Received
WILLIAMSON COUNTY, TEXAS
CHANGE ORDER NUMBER: 1

Project: 1604-075
Roadway: CR 110 South
CSJ Number: _____

**County Road 110 South
Williamson County Project No. 1604-075**

Change Order No. 1

ROADWAY PLAN AND PROFILE
MOZART ST

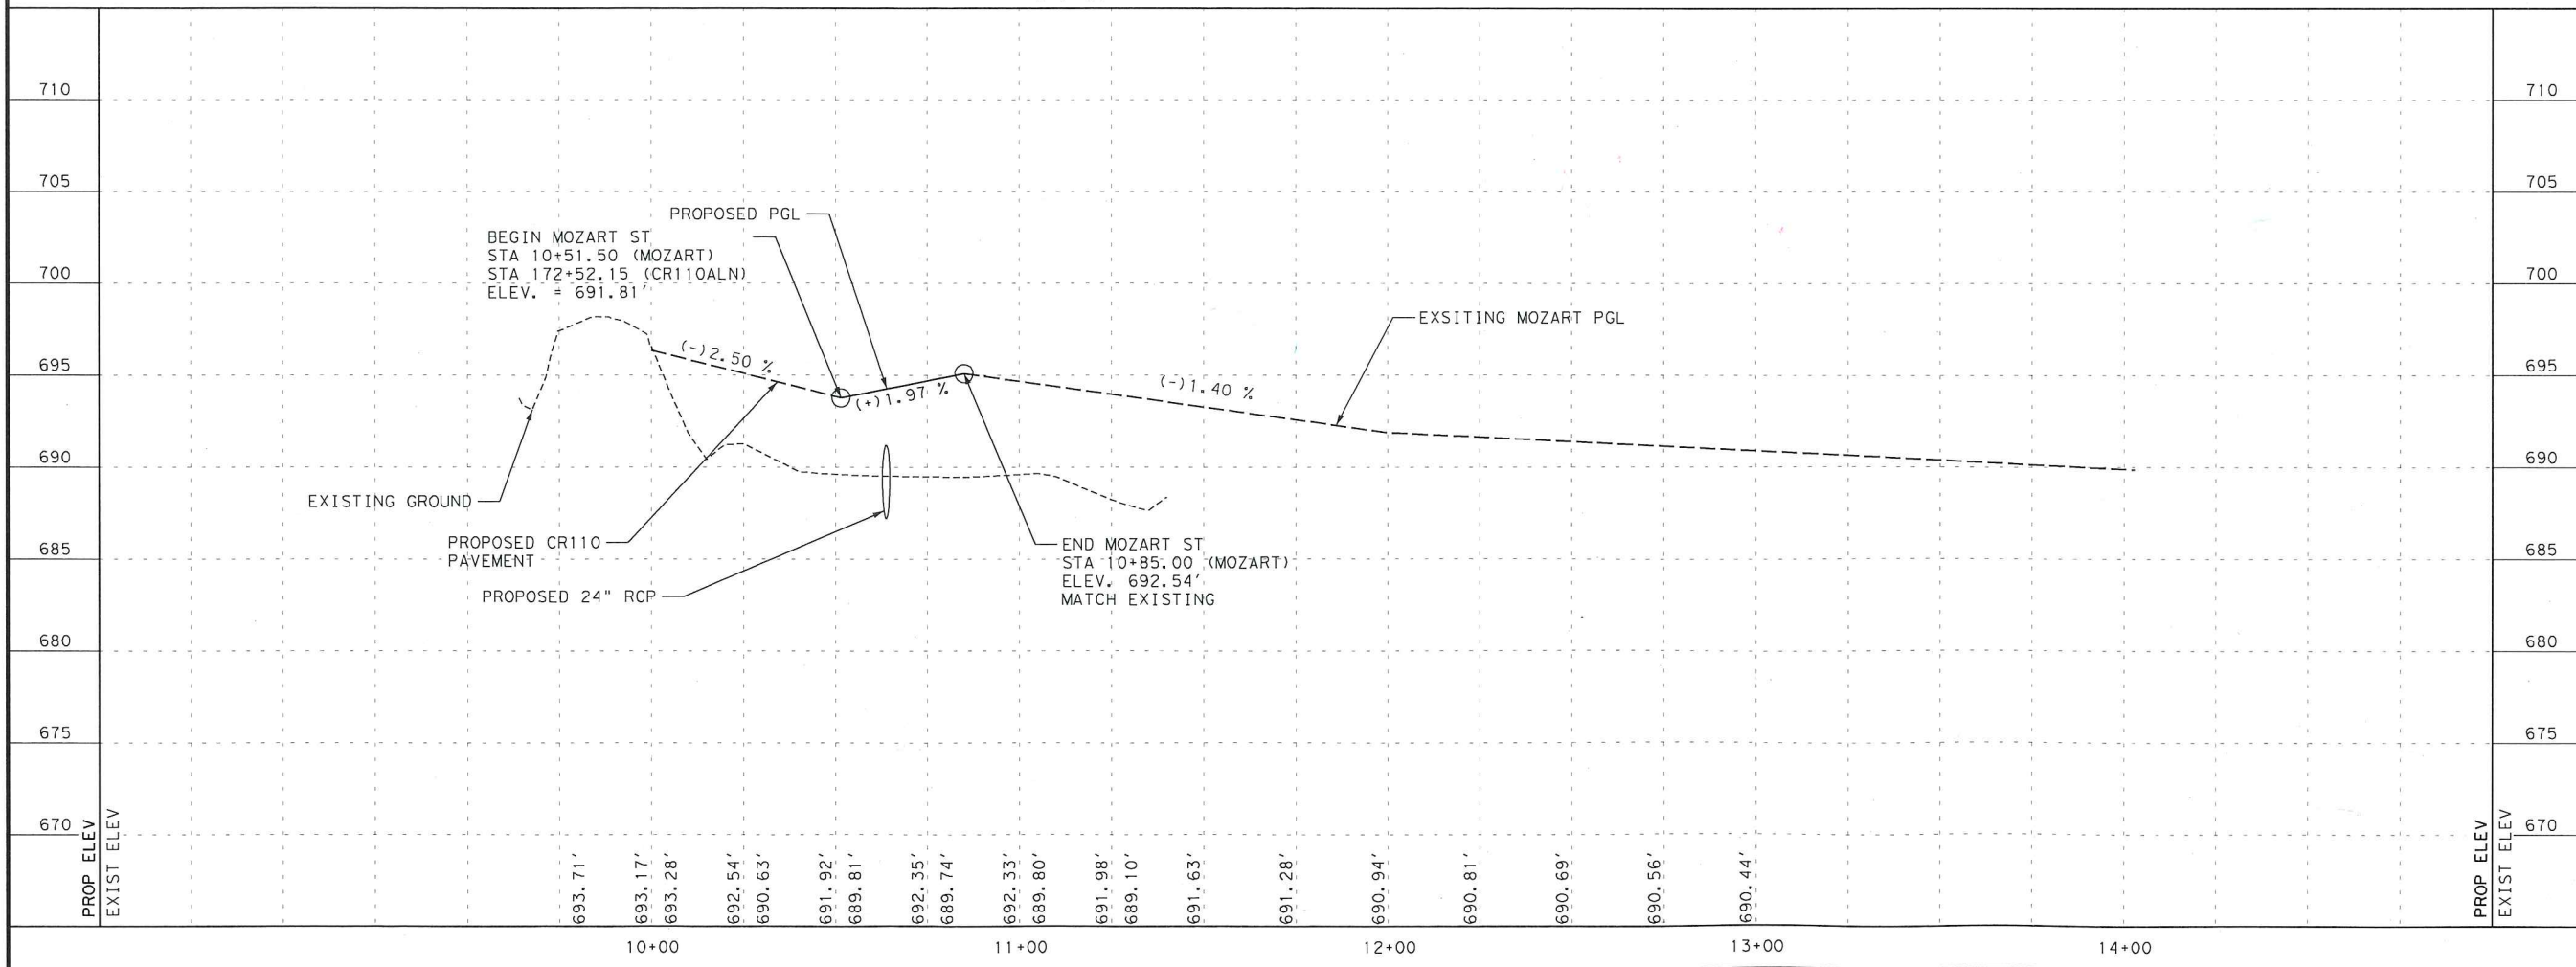
This Change Order also provides a correction to Mozart Street, which was constructed after the design of CR 110 South. Additional plan sheets showing the required tie-in details were added to the plan set and issued to the Contractor for construction. This Change Order documents the required Contract changes and provides payment specifics for the Contractor. The following new Contract items are required for the required plan revisions. The unit rates submitted by the Contractor are consistent with the TxDOT average low bid unit prices.

CR 110 SOUTH
CULVERT
CROSS
SECTIONS

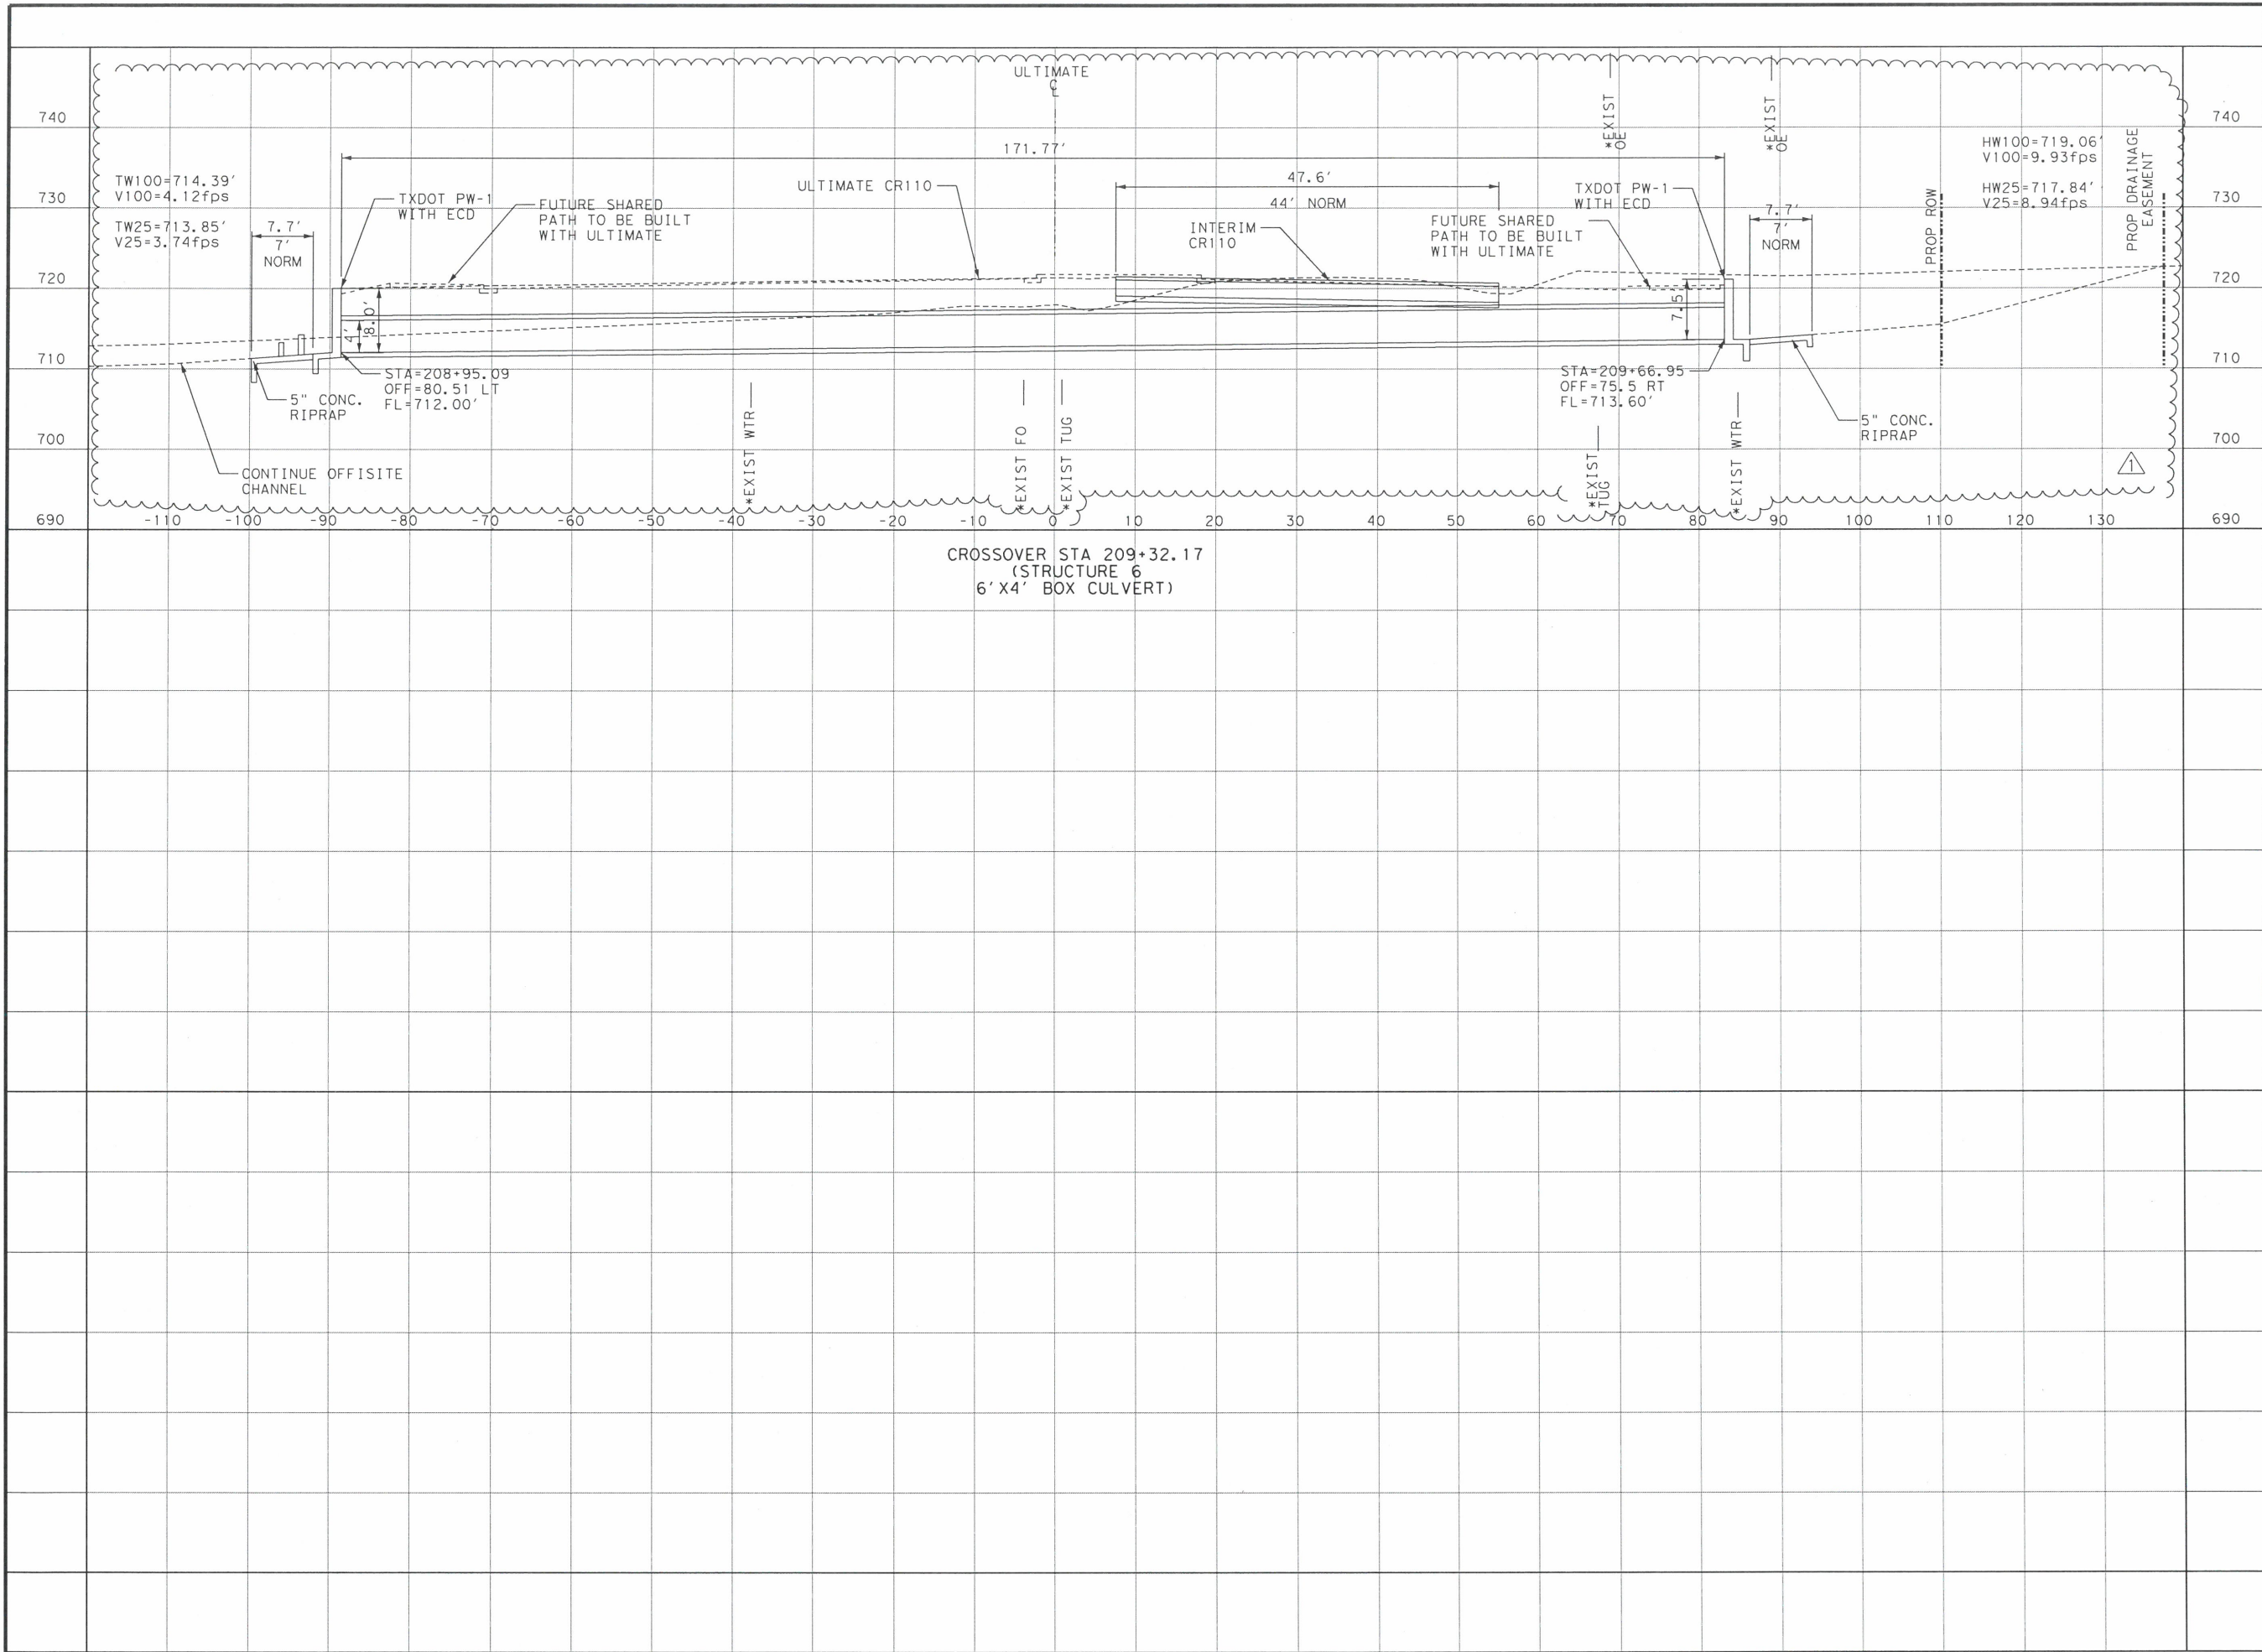
This Change Order modifies the outfall location of Box Culvert 6 to match existing conditions, per the request of the downstream property owner. This redesign resulted in a decrease of the total box culvert length and quantity changes for various other drainage structure items.

DATE	BY	REV	REVISION
11/02/16	NA	1	CULVERT REVISION

CULVERT
GRADING

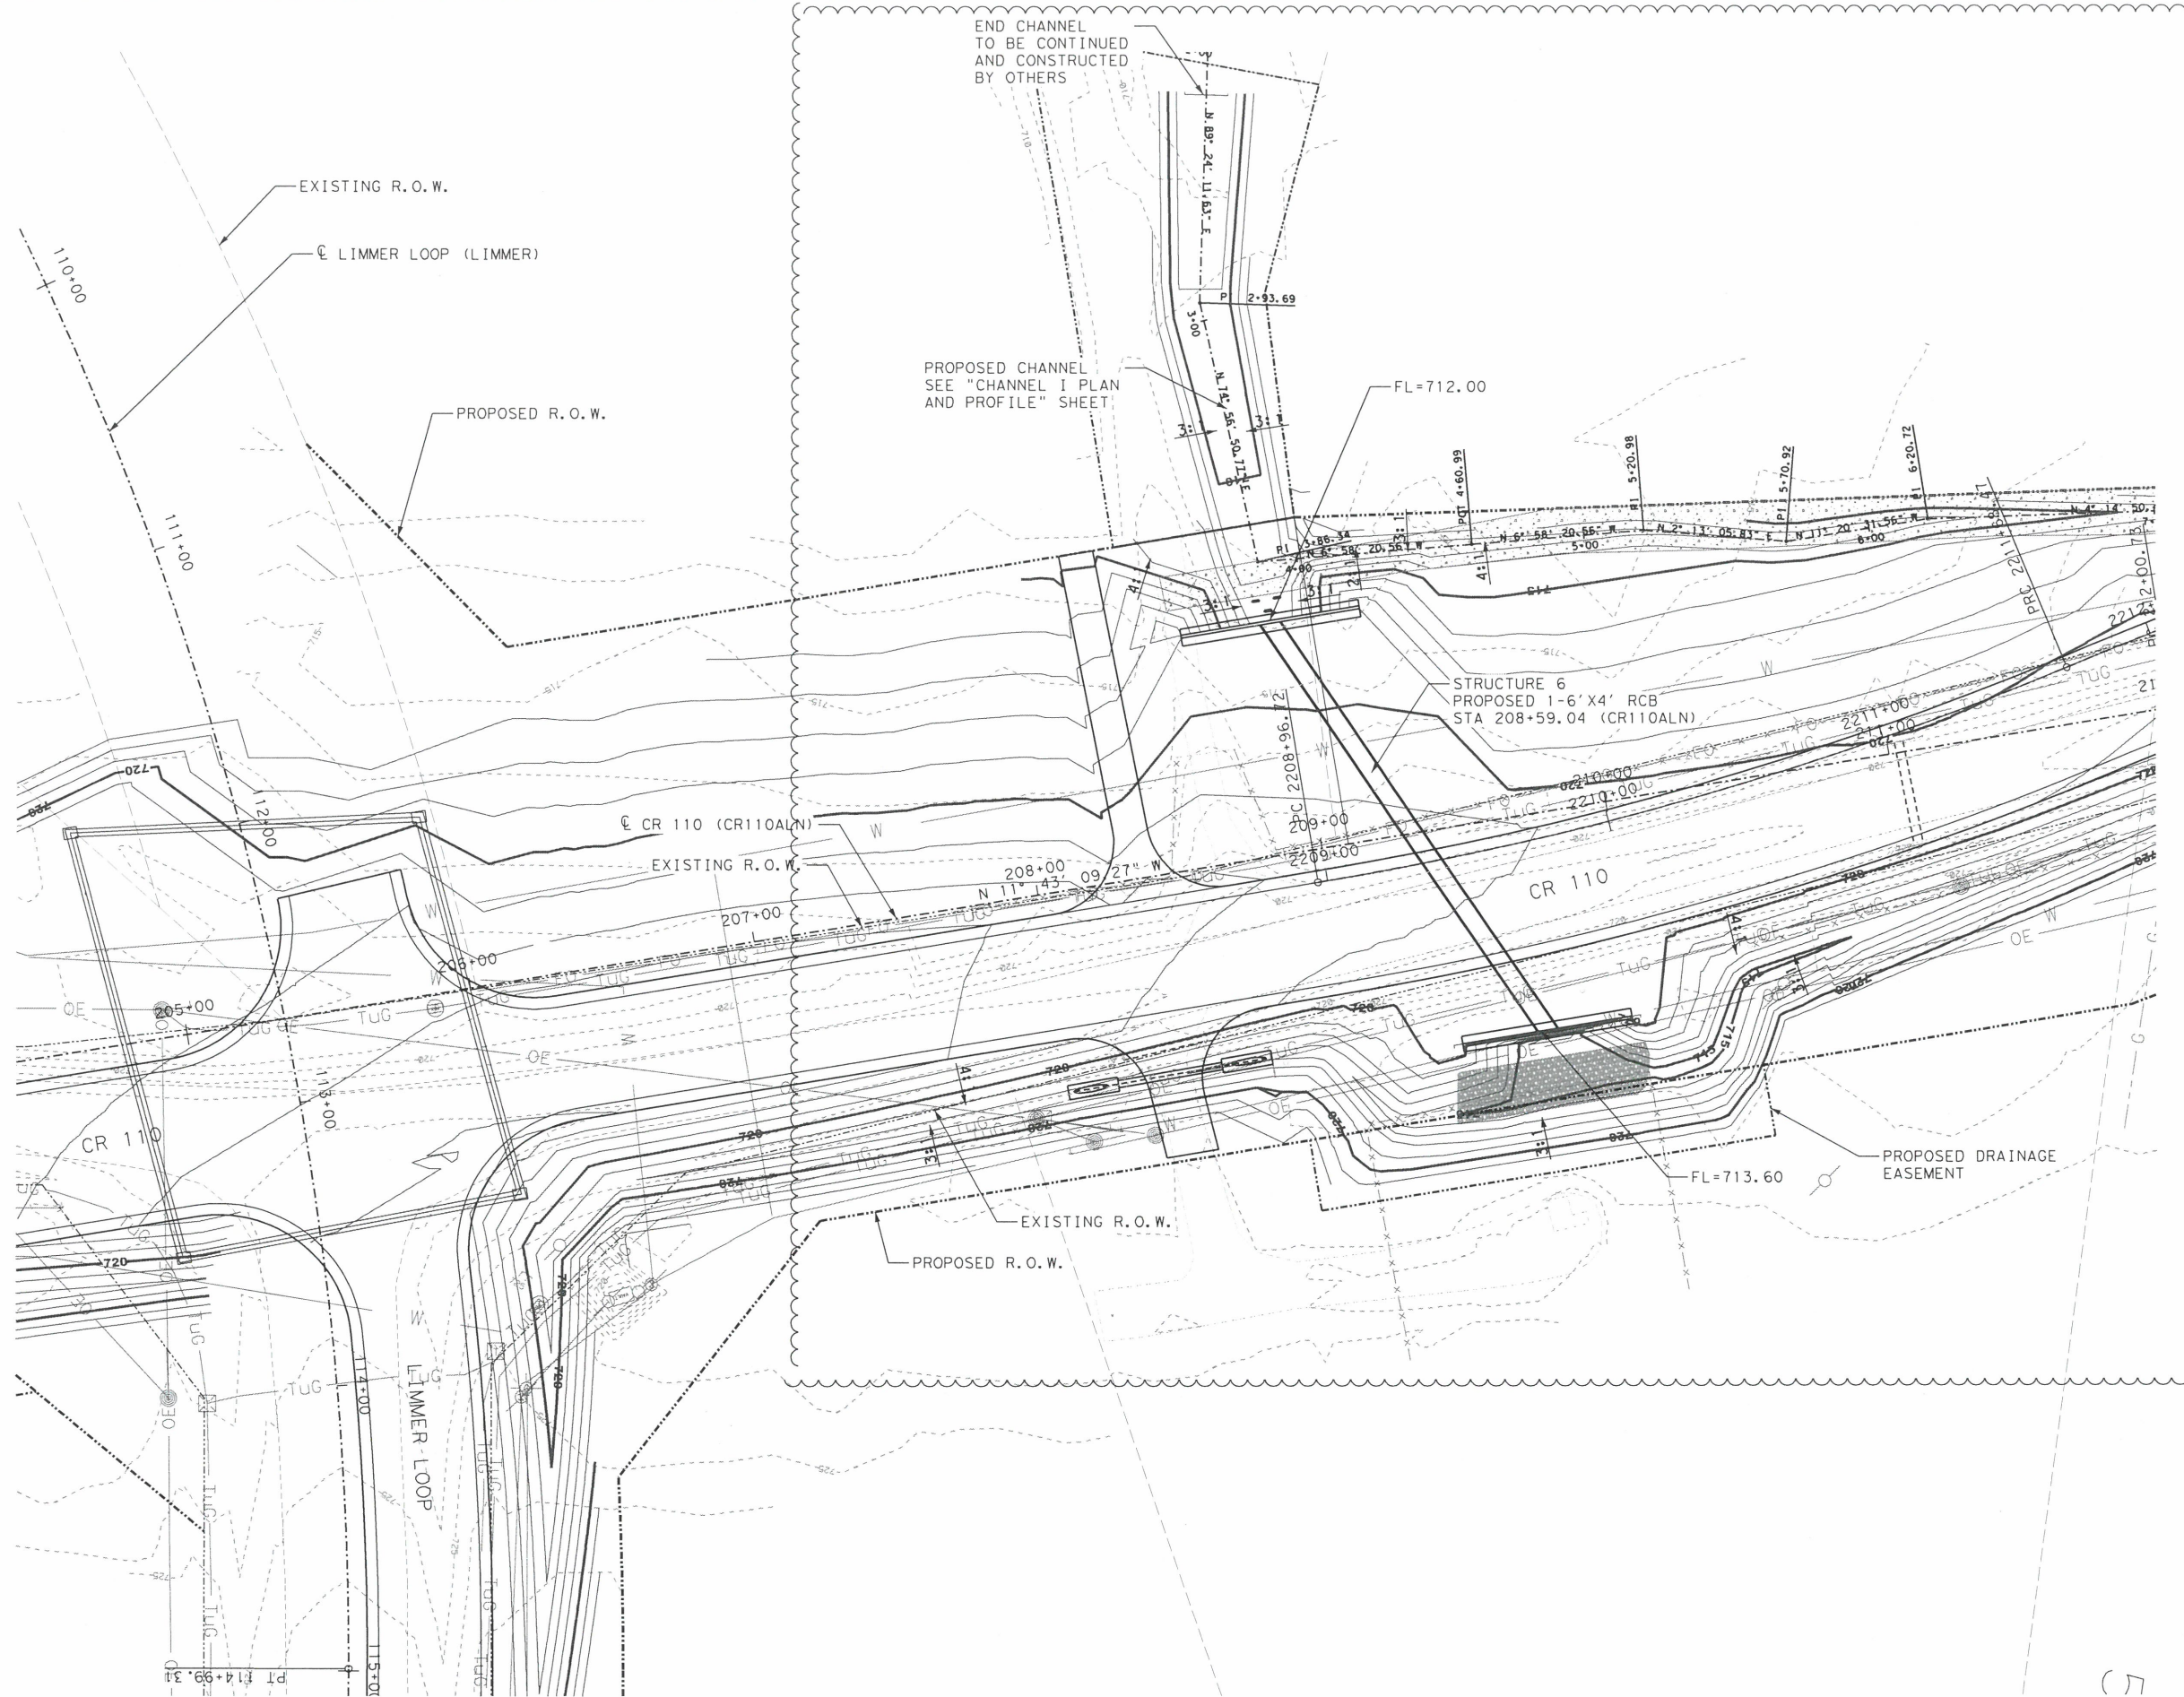
DATE: 11/02/16 BY: NA REV: 1 REVISION: CULVERT REVISION
